NONCONFORMANCE-REPORT LOG & STATUS BOOK

PROJECT NO. 7220

Subject: Consumers Power Company
Midland Plant Units 1 & 2
Job No. 7220
Reinforcing Steel
File: P.O. 7220-C-39 (PR)

DR. ED	CHK. R.E.S.	DATE 2-15-74
BECHTEL POWER CORP. MIDLAND PLANT 112		
UNIT "2" SUMP 10" DIA. SLEEVE RELOCATION		
JOB NO.	DRAWING NO.	
7210	ESK C-03

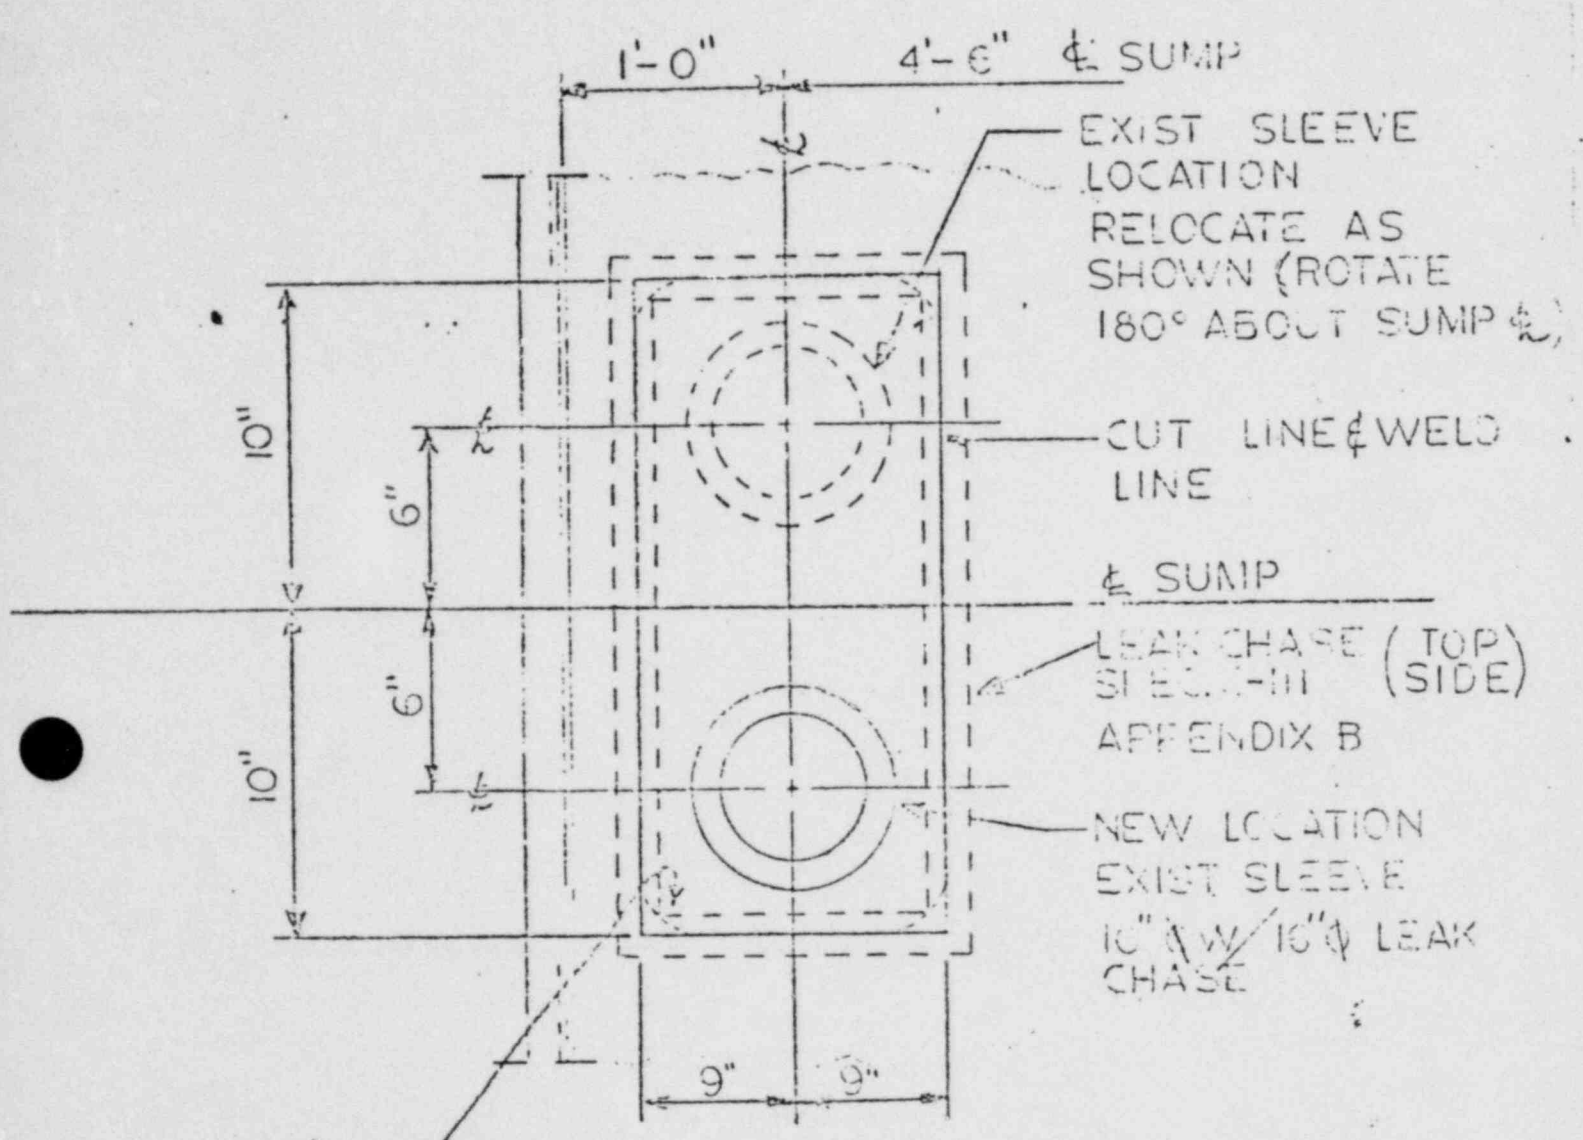
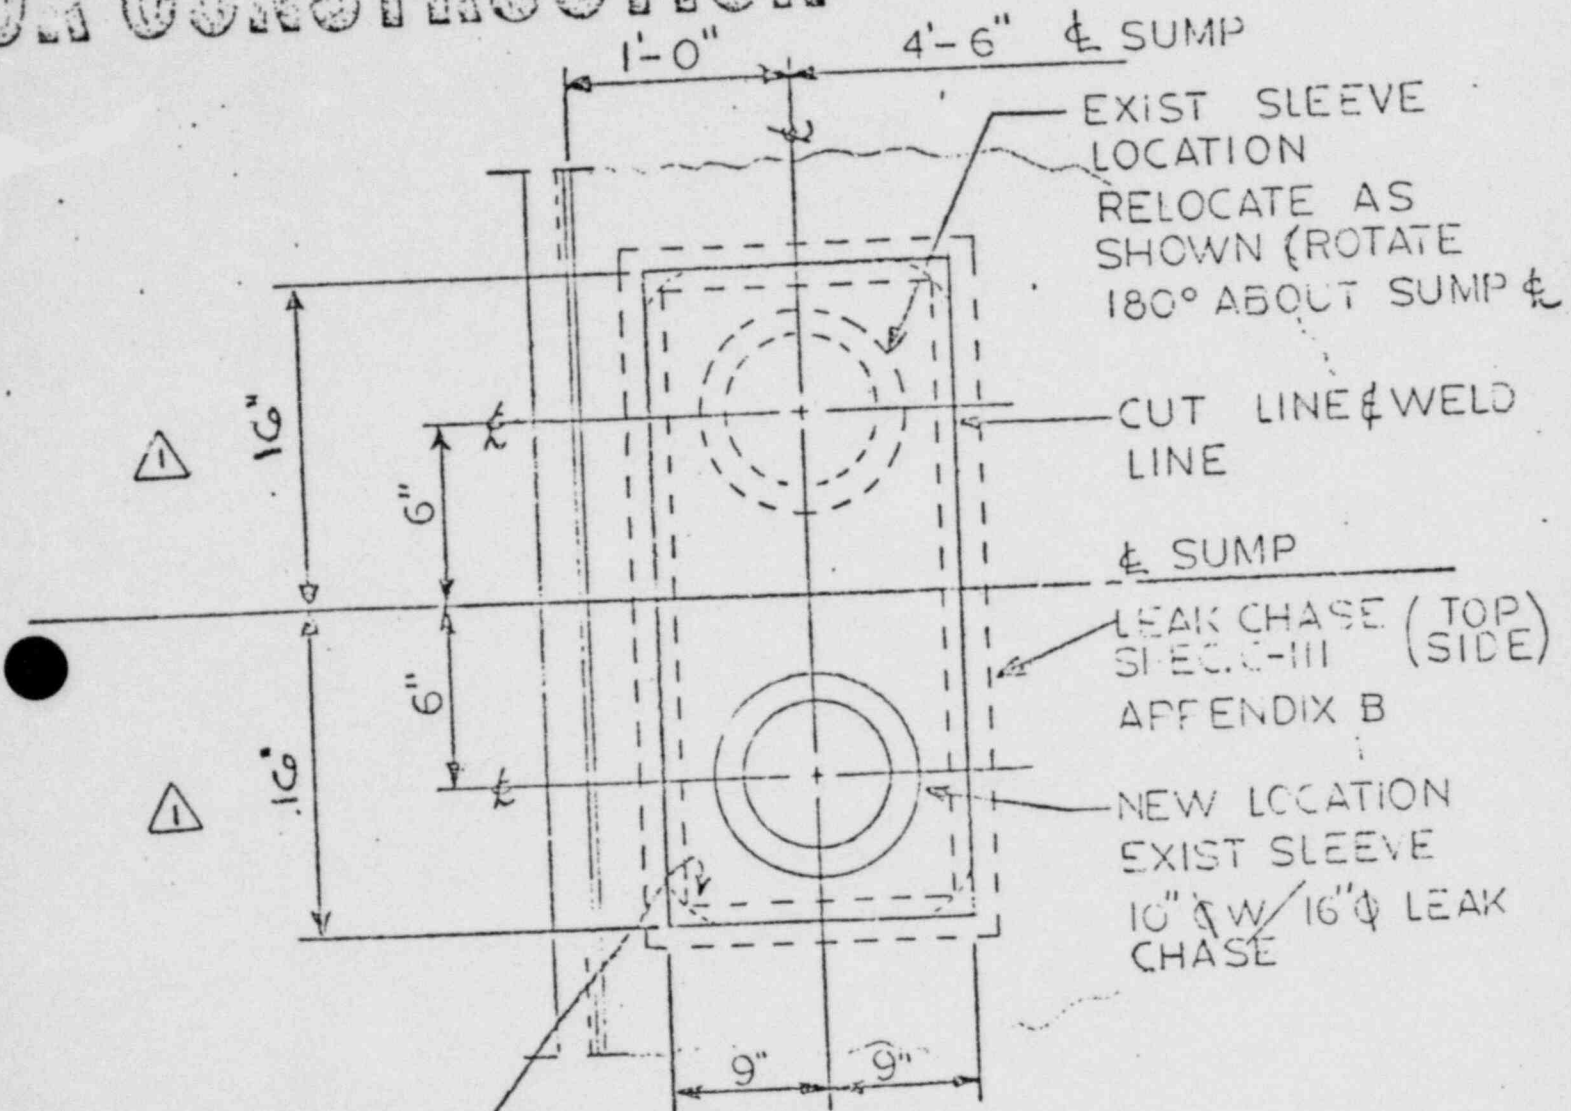
1. O.K. to install sump liner plate in containment No. 2 prior to N.C.R. completion.

2. N.C.R. shall be completed prior to pouring concrete into sump.
